# construction bid document addendum 02

project: Southern Maine Community College - Horticulture Greenhouse  
Midcoast Campus, Brunswick, Maine BGS # 3674

date: 15 November 2024

## HORTICULTURE GREENHOUSE

DRAWINGS    Civil                    [Not Used]  
                         Architectural

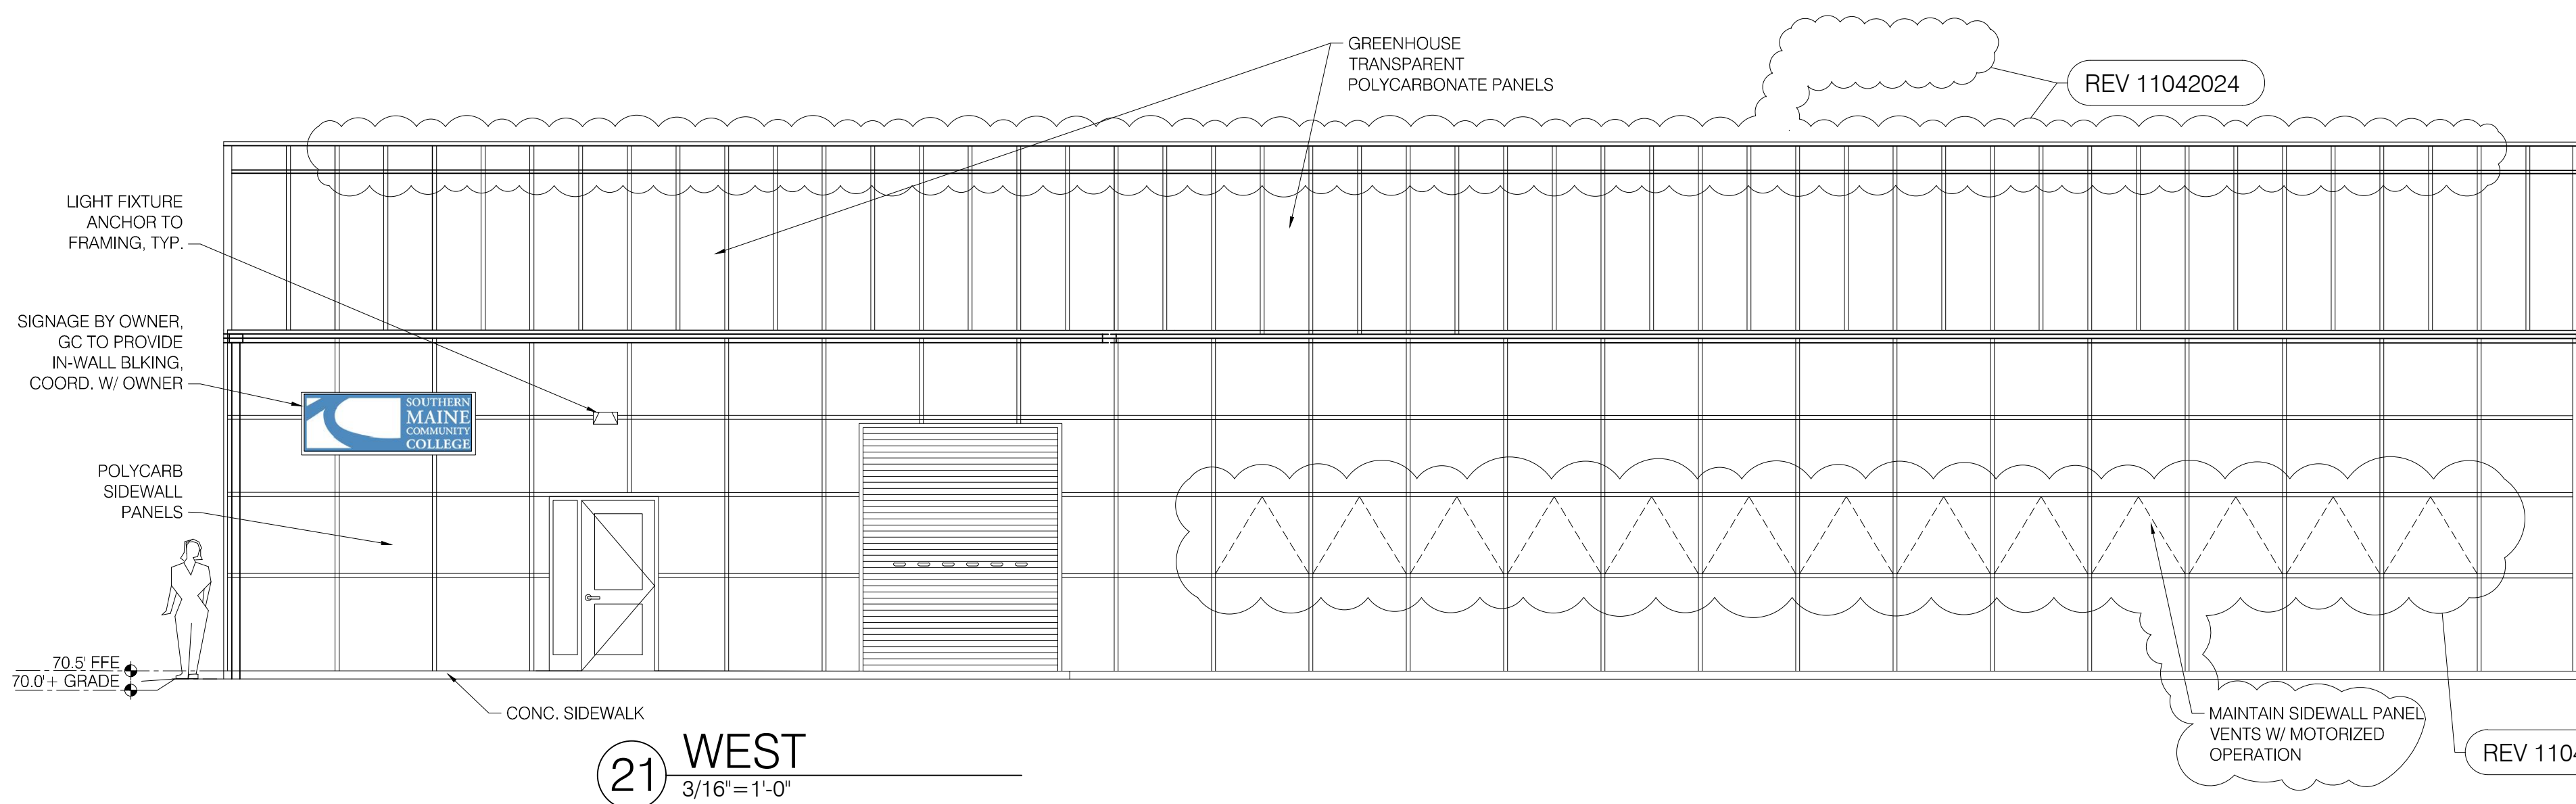
A20 EXTERIOR ELEVATIONS: Motorized wall panel ventilation to be retained with reduction of east wall side vents as shown.
